ENCLOSURE
SAFETY EVALUATION
WOLF CREEK GENERATING STATION
DOCKET NO. 50-482
RHRS LTOPS MODIFICATION

Introduction

Schematic
RHR Suction Relief Valves

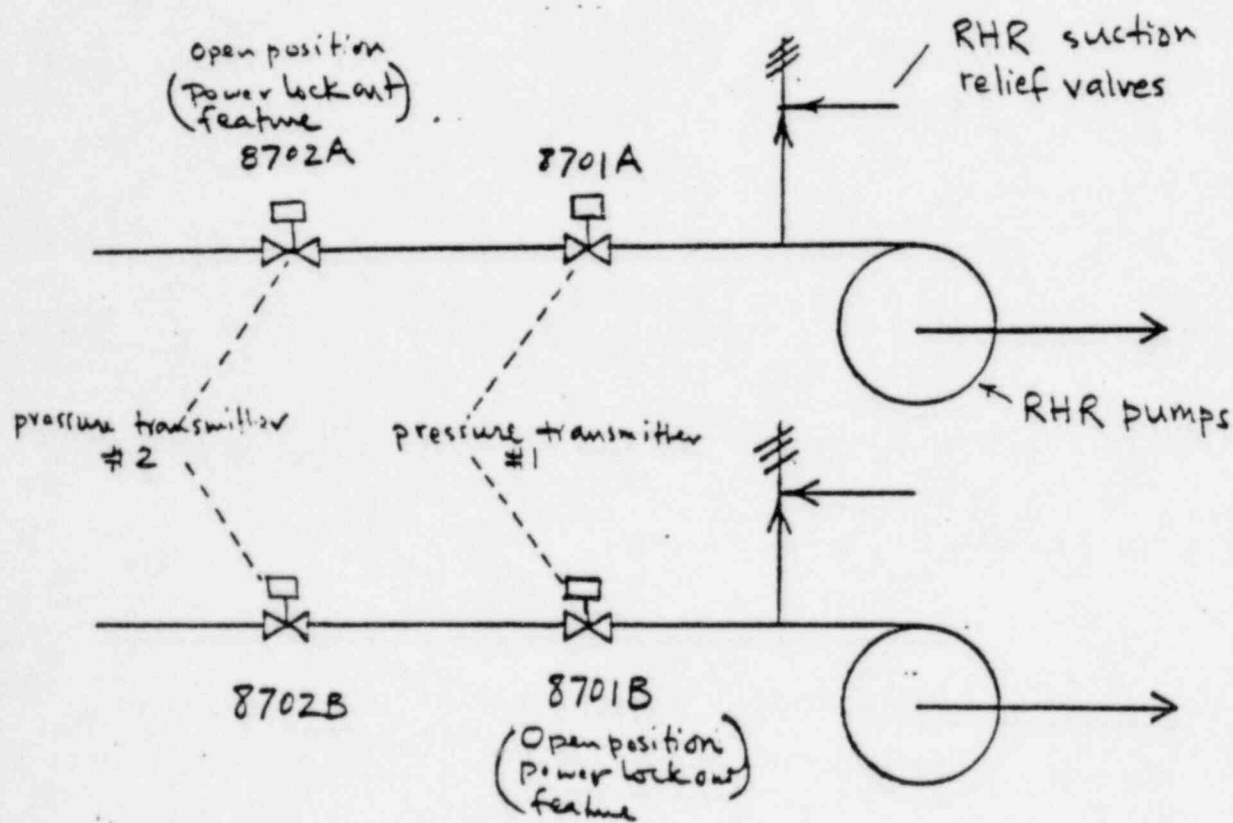
When the LTOP protection to the plant is provided by the RHR suction relief valves, all four RHR suction MOVs are opened to provide the required redundancy of the pressure relieving capacity. However, a single failure in one pressure transmitter could actuate the auto close interlock, thus isolating both RHR trains, causing an overpressure event by the loss of the letdown flow, and defeating the LTOP protection. To eliminate this single failure and render the LTOP a single-failure-proof system KG&E proposes the following.

On decreasing RCS temperature and pressure to the RHRS entry conditions, when relying on RHRS for LTOP protection, the licensee proposes to open the four suction MOVs, then remove and lock out the power to MOVs 8702 A and 8701 B. Valve opening and power removal are specified in the plant's Technical Specifications.

Removing power to these two valves (defeating the interlocks) not only protects the RCS from single failure causing isolation of both RHRS suction relief valves (loss of LTOPS), but also provides protection for both RHR pumps, when in operation, from a loss of suction due to a single pressure transmitter failure. Inadvertent isolation of the RHR suction valves has been a concern at other plants and has resulted in damage to a RHR pump.

- (a) Administrative procedures to verify that power is restored to valves 8702A and 8701B and the valves are closed prior to exceeding the RHRS suction relief setpoint (this administrative procedure has already been implemented at the plant).
- (b) Add an alarm circuit to the valves with the power locking feature, namely 8702A and 8701B, such that if any of these valves are open or do not have power available and the interlock activation setpoint is reached, the alarm would initiate on the main control board. If

the alarm initiates an annunciator alarm response, procedure would require closing or verifying closure of the affected RHR suction isolation valves.

The existing auto close interlock has no visual indication in the control room (other than valve position indication). Therefore, if a signal is generated to close the valve and the valve fails to close, the operator would not be alerted. With the addition of the proposed alarm circuit, if the valve is open or if power is not available and the pressure setpoint is reached, an alarm is generated in the control room giving the operator positive indication. Therefore, protection is afforded if the operator fails to restore power or if the interlock actuates and the valve fails to close. Additionally, alarm response procedures would provide positive operator actions.

The staff has reviewed the licensee's proposed system and procedural modifications to the Wolf Creek LTOP system and has reviewed the plant's Technical Specifications and concludes that in light of the plant's TS these modifications are acceptable and that the LTOP reliance on the RHRS suction relief valves meets the intent of the Standard Review Plan sections 5.2.2 and 5.4.7 and their associated Branch Technical Positions 5-2 and 5-1 respectively. Therefore, we conclude that the requirements of License Condition (13) have been met.
